STRUCTURAL REPORT
FOR THE
BILLINGS CARRIAGE BARN
WOODSTOCK, VERMONT

MARCH 30, 1988

Billings Carriage Barn
Woodstock, Vermont
Project #8806

FIRST FLOOR FRAMING PLAN - SCALE 1"=10'±

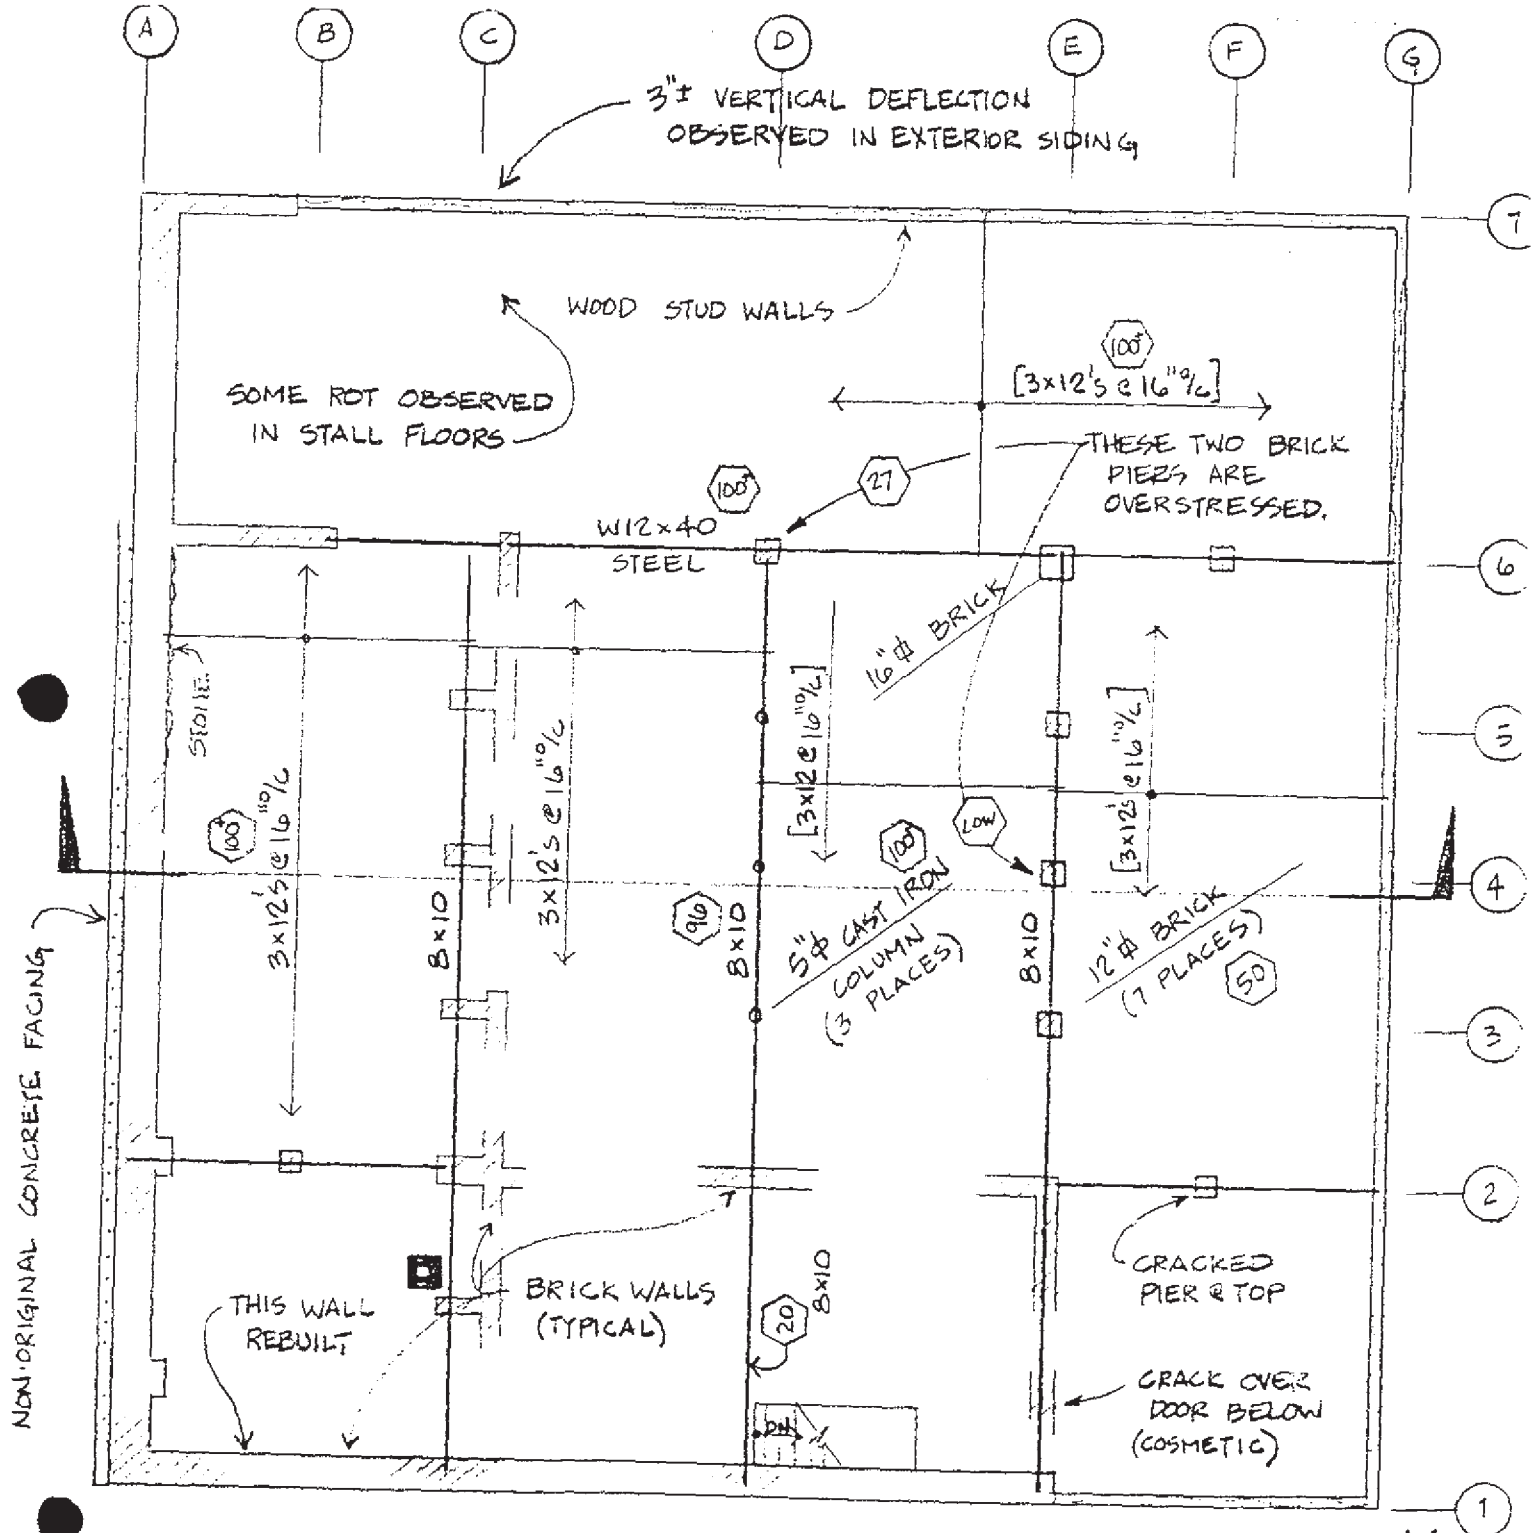
- A. 8x10 Wood Beam - The 8x10 between D1 and D2 spans twice as far as the typical 8x10 and consequently has a much lower Live Load Capacity.

- B. 12x12 Brick Piers - Two of the brick piers (Grids D6 and E4) are overstressed. E4 was undersized in the original design and the condition at D6 became a concern when the two adjacent brick piers were removed during past renovations (when the W12x40 steel beam was installed).

Our recommendation is to replace all of the brick piers (7 locations). Two are overloaded, the one at F2 is cracked at the top and there is some evidence of "dead" mortar and soft brick throughout this level. With temporary shoring, the replacement should be straightforward and considering the importance of these piers, should be done.

- D. Floor Beneath Stalls - This section of floor is the northern most 10'± of the building between A and D. There is some evidence of rot and, considering its use, it is not surprising.

6. Wall Construction - There is a noticeable (3"±) vertical deflection in the exterior clapboard siding at grid C7 (Refer to Sheet #1) and some distress noted at Grid C6 (Refer to Sheet #2). We were not able to remove wall finishes to observe the framing in the walls but this distress is probably related to the concentrated loads at the bearing of the loft level wall trusses.

We recommend this be strengthened by either increasing its size or adding a support near centerspan.

We recommend this floor be exposed prior to any major renovation to verify the condition of the floor framing beneath the floor boards.

The walls at C6, C7, E6 and E7 should be opened to expose the existing construction and reinforced if necessary.

LOFT FRAMING PLAN

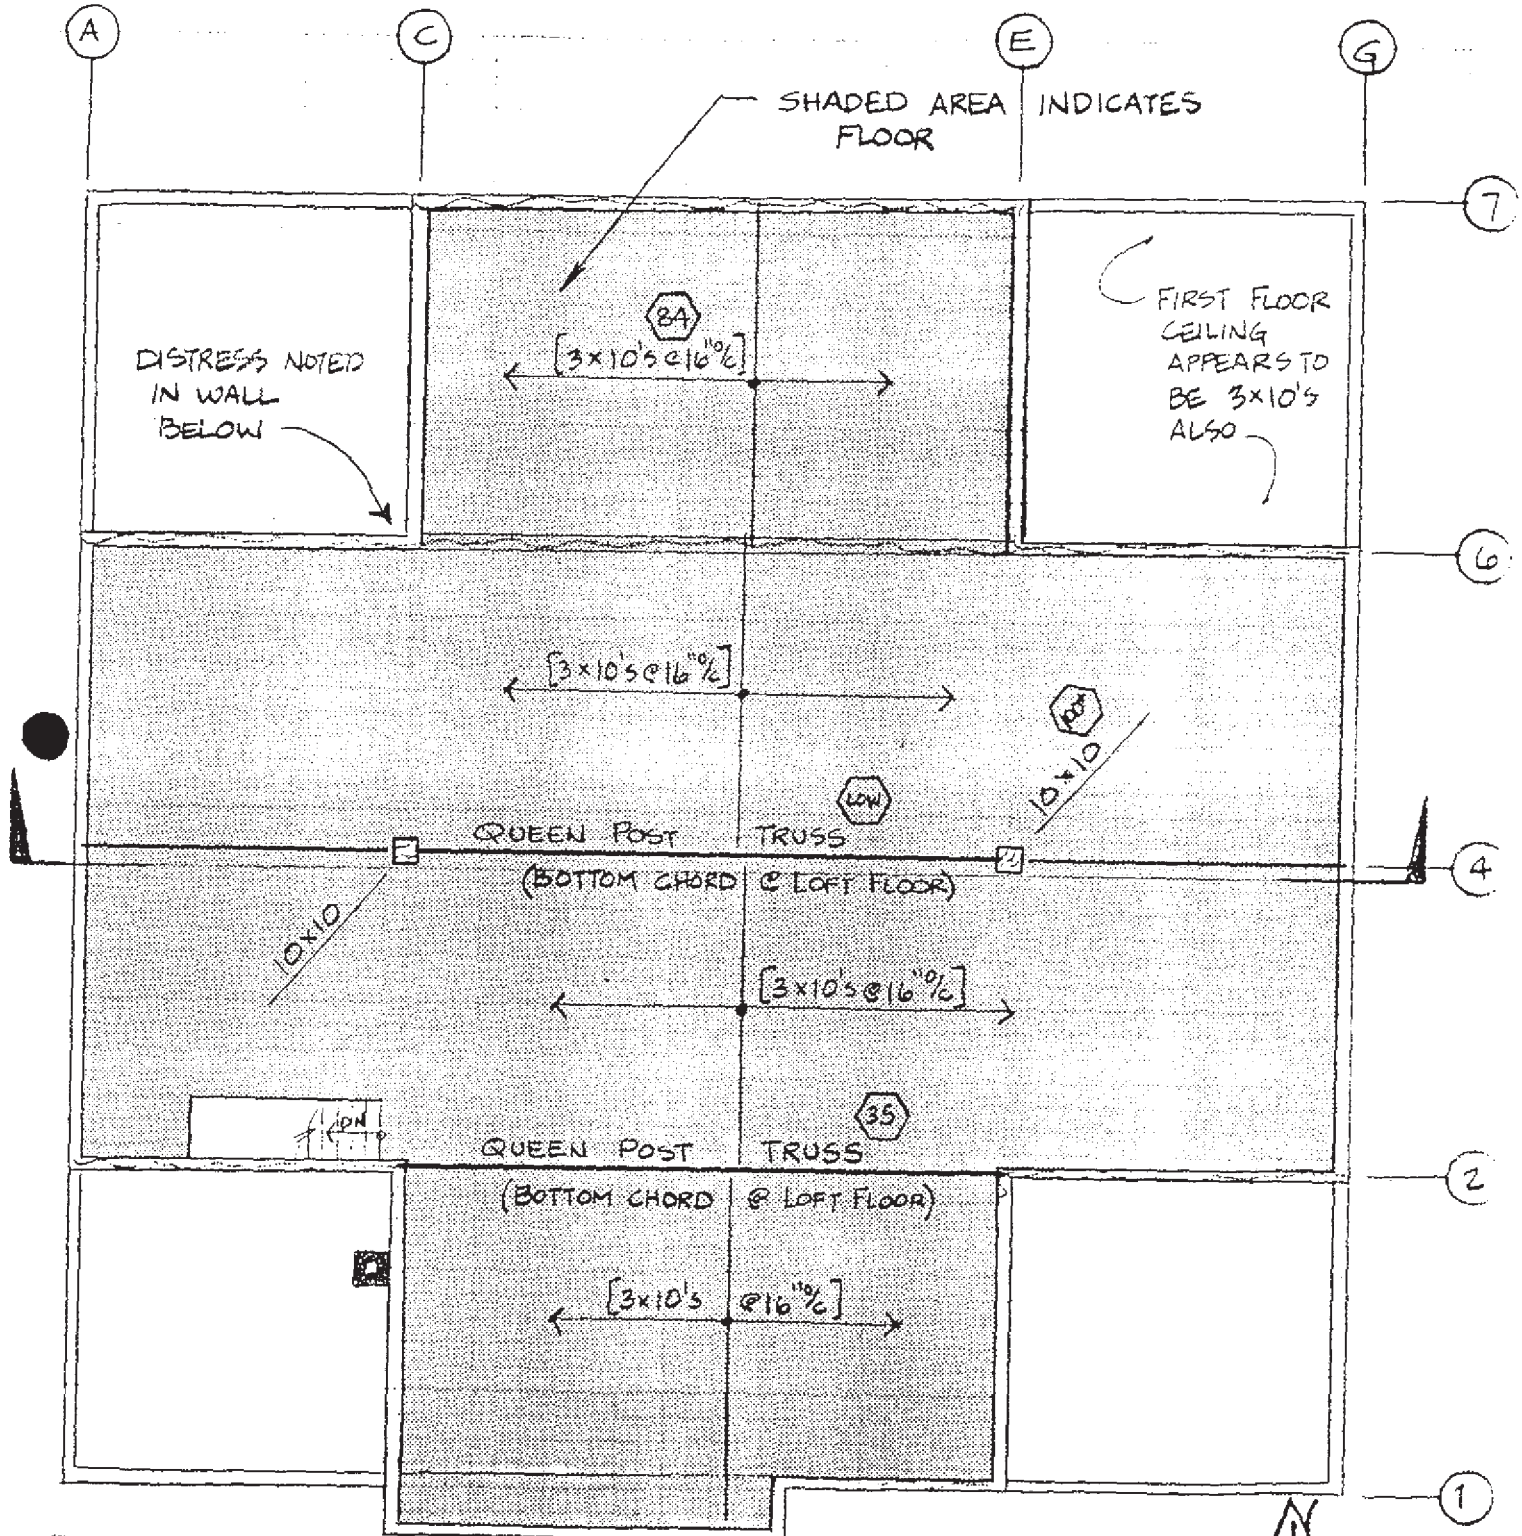
3. Chimney - There is a brick chimney in the southwest section of lower roof that is susceptible to damage from sliding snow and ice. Although the masonry chimney is braced to the roof, we recommend a proper sized cricket be constructed to minimize the possibility of damage.
4. Loft - As noted in Item 1, the Queen Post Truss on the 4 line is overstressed by the 4 skewed 6x6 struts that support the valleys of the roof. Even without the loads from the struts (as on the 2 line) the Queen Post Truss has a relative low (35 psf) Live Load Capacity.

We recommend that the 4 line truss be strengthened if any loft level live loads are added and that the 2 line truss be strengthened if the loft level is used for more than attic type loading. The strengthening would involve replacement of the vertical rods with steel of higher strength and better bracing of the top chords. We were not able to observe the bearing conditions of these trusses. They should be exposed to verify their capacity.

ROOF FRAMING PLAN

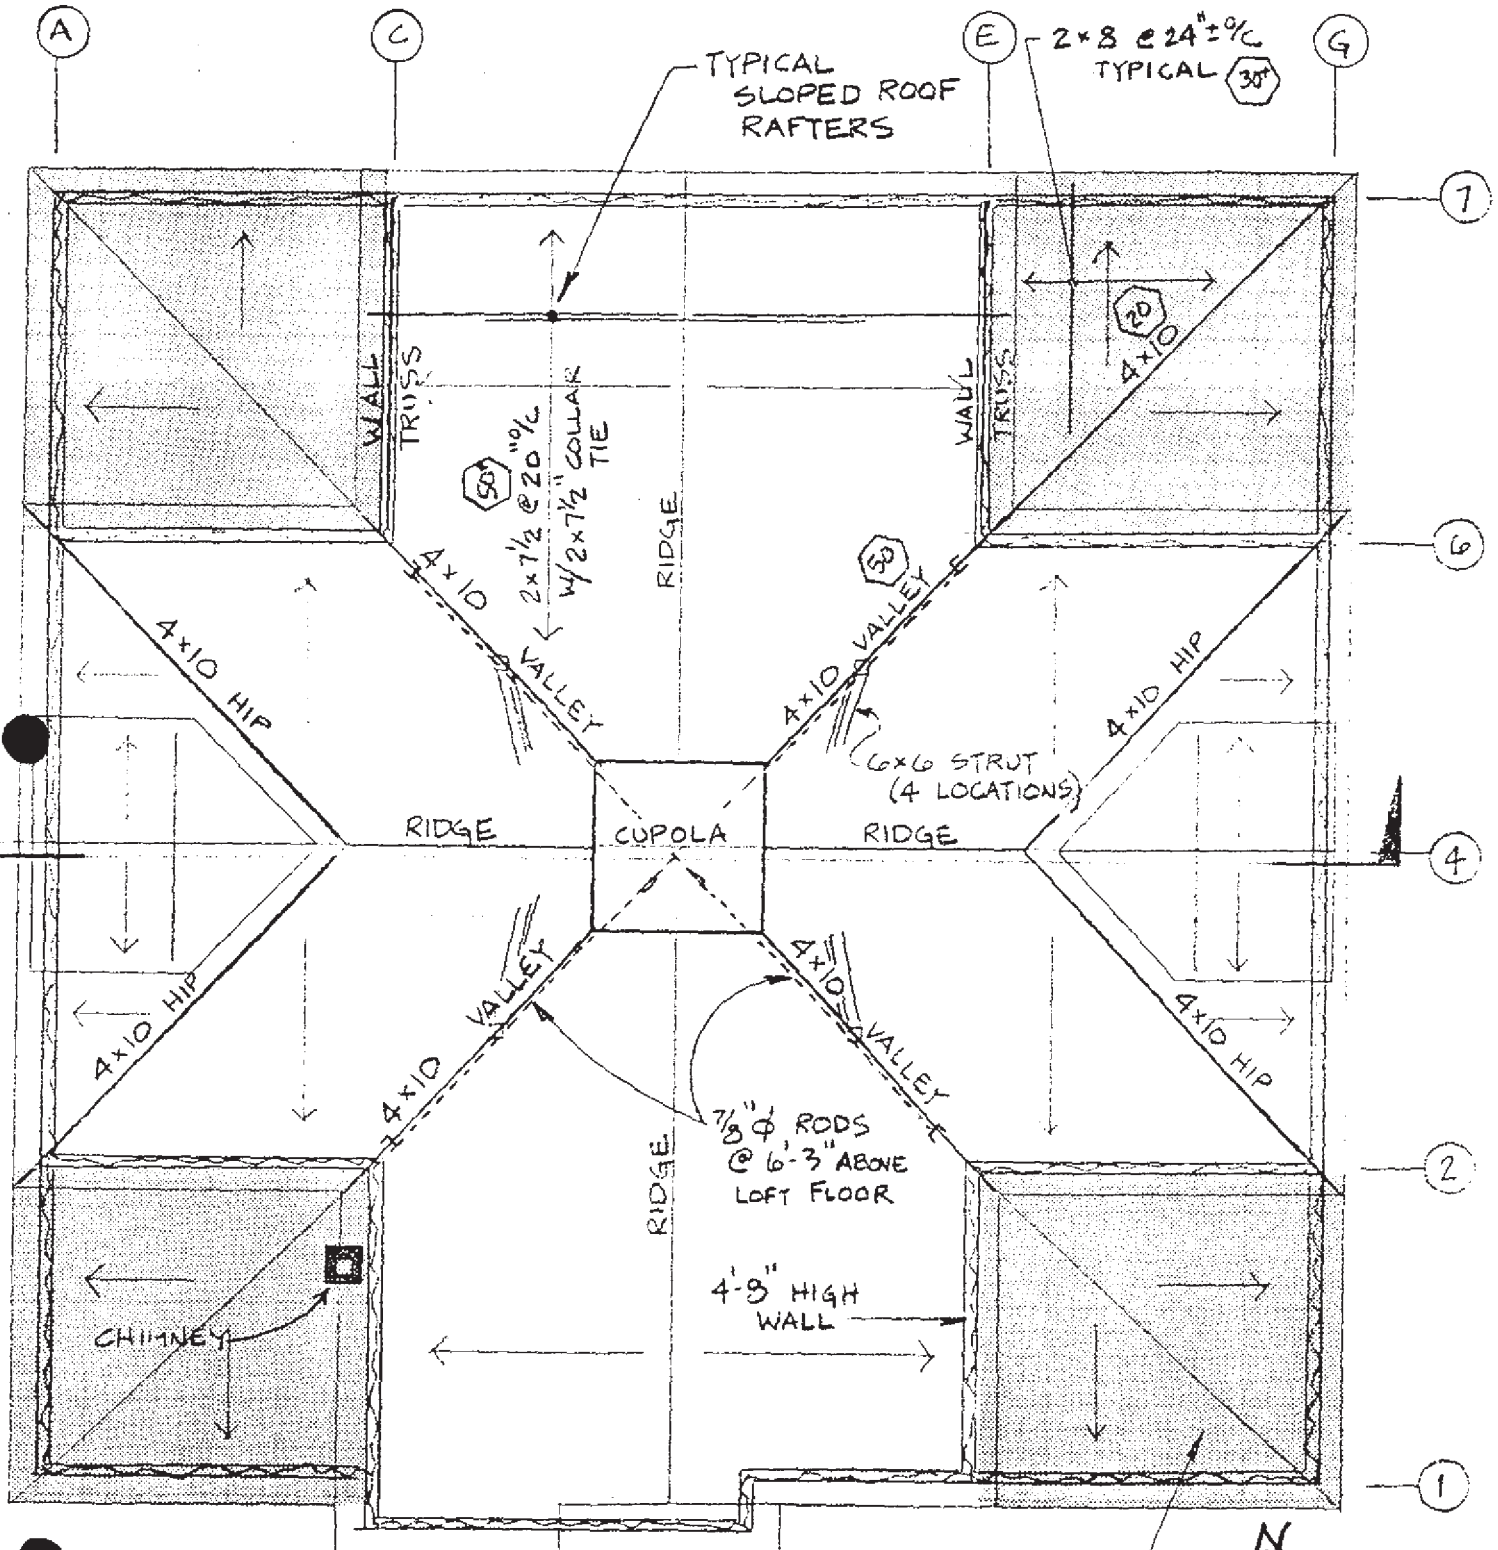
1. Main Roof - The original design made no provision for the horizontal thrust at the lower end of the four valley beams. This thrust has resulted in a very noticeable (up to 3") outward movement where these valleys are supported at Grids C2, E2, C6 and E6. This problem is compounded by the fact that the loft level knee walls are also not restricted from outward movement as they support the sloped roof rafters.

2. Lower Flatter Roofs - These sections are not capable of safely supporting the anticipated drifting and sliding snow from the main roof. These roof sections (refer to Sheet #3 for location) are a good example of how wood has an ability to re-distribute loads when overloaded. The presence of wood blocking (presumably installed after the original construction) transfers some roof loads down to the first floor ceiling joists. This improves the roof's capacity but, since the blocking appears random the condition still requires improvement.

We recommend that the roof be properly stabilized. The solution is not simple. A detailed study will be required that considers proposed future use as well as proper structural design. Conceptually, the corrective work could involve more or larger horizontal rods, reinforced knee walls, reinforced valley beams or even a new line of support that could be established by extending the 10x10 wood columns at C4 and E4 up to the roof. Acceptable structural solutions will be restricted by the proposed final use of this level.

We recommend these sections be strengthened. The work might involve removal of the roofing and wood deck due to restricted work space or perhaps could be done from underneath if carefully thought out. This work should be coordinated with the knee wall stabilization work mentioned in Item 1.
